Cambridge Waste Water Treatment Plant Relocation Project  
Anglian Water Services Limited

# Appendix 8.14: Landscape, Ecological and Recreational Management Plan

**Revision No. 03**  
19 February 2024

<b>Version</b>	<b>Date</b>	<b>Author</b>	<b>Description of change</b>
01	30.01.23	-	DCO Submission
02	19.09.23	-	Updated Table 4.2, Figure 3.7 and Figure 3.13
03	22.01.24	-	Section 4 and Appendix A updated to reflect actions from ISH3
<u>04</u>	<u>-15.02.24</u>	<u>-</u>	<u>-Updates following ExQ 2, and inclusion of Figure 3.1b</u>

**Figure 3.1b Landscape Masterplan identifying screen planting**

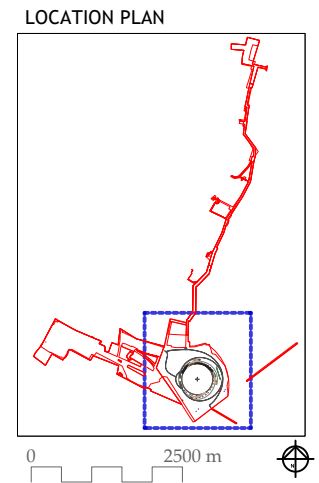
REVISIONS		
I1	16.02.24	Response to Examination query

<p>Proposed screen planting (<a href="#">see Figure 3.1 Landscape Masterplan identifying screen planting</a>)</p> <p><a href="#">These are supplementary to the provisions above for Proposed new tree, shrub and hedgerow planting and specific to the additional attention to screen planting due to its function</a></p>	<p><b>Aim:</b> To ensure for a minimum period of 30 years that planting has the best chances of longevity and screening.</p> <p><b>Objectives:</b></p> <ul style="list-style-type: none"> <li>• To manage in a way that ensures good survival rate and establishment;</li> <li>• To maintain the health, visual amenity and screening properties of the trees;</li> <li>• To maintain appropriate forms of trees for future growth; and</li> <li>• To ensure trees do not pose a hazard to users.</li> </ul> <p>Watering: Irrigation shall be minimised and limited to the first year for all new planting and the second year for earth bank planting only. In the subsequent three years, trees and hedgerows on the earth bank will receive supplemental irrigation to ensure they establish. If prolonged periods of drought or high temperatures pose a threat to the plantings, their screening capacity or the habitats that have established, then a review of key mitigation planting and its irrigation will be held and responsive and targeted watering will be implemented to ensure best chances. One of the tasks for the Advisory Group (see 4.1.2) will be to review the watering response strategy prepared for the detailed management</p>	<p><del>-A minimum period of 30 years</del> <del>Not applicable</del></p> <p><del>-A minimum period of 30 years</del> <del>Not applicable</del></p> <p>Variable – <a href="#">first year for all new screen planting, years 2 to 5 for earth bank planting and then for earth bank planting in response to conditions</a></p>
